ADDENDUM NUMBER 02

PROJECT: **RICKWOOD CAVERNS STATE PARK – POOL HOUSE**

PROJECT NUMBER: **ASPD PROJECT #: 2025-022-1616**

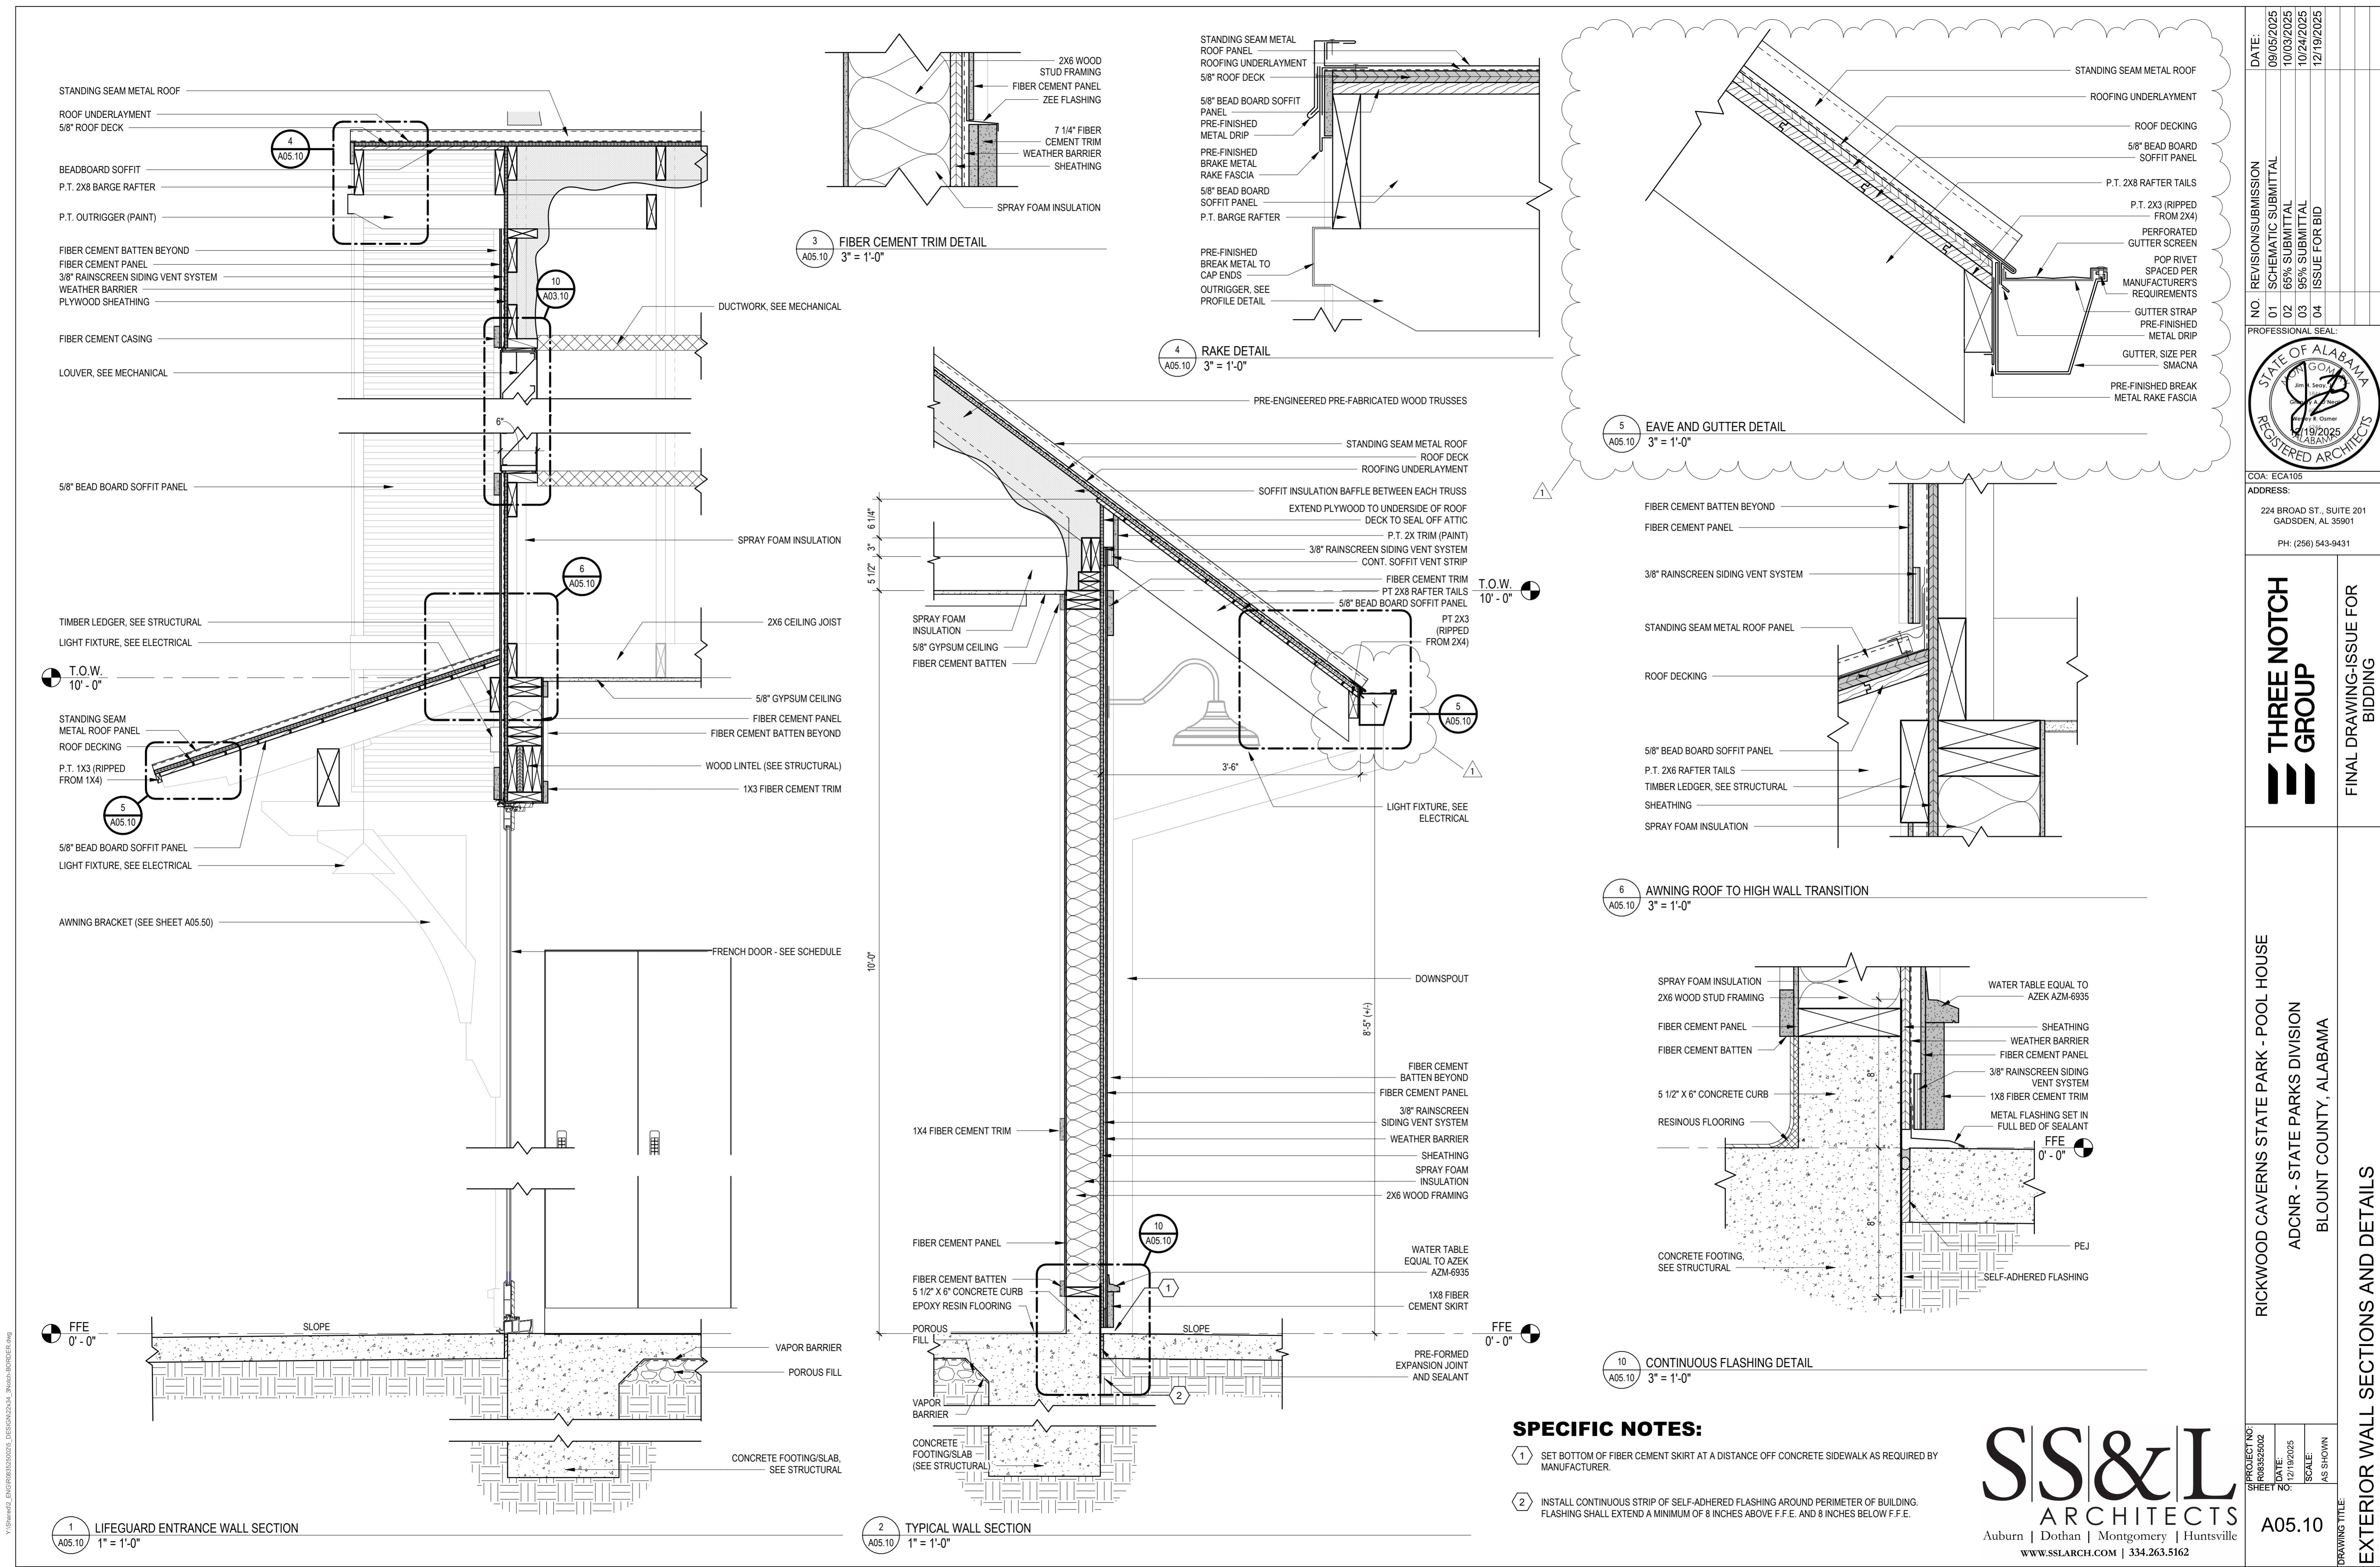
- 1. Sheet A05.10**
 - a. Section 2/A05.10: Gutter guards have been added.**
 - b. Detail 5/A05.10: Gutter Guards have been added and indicated.**
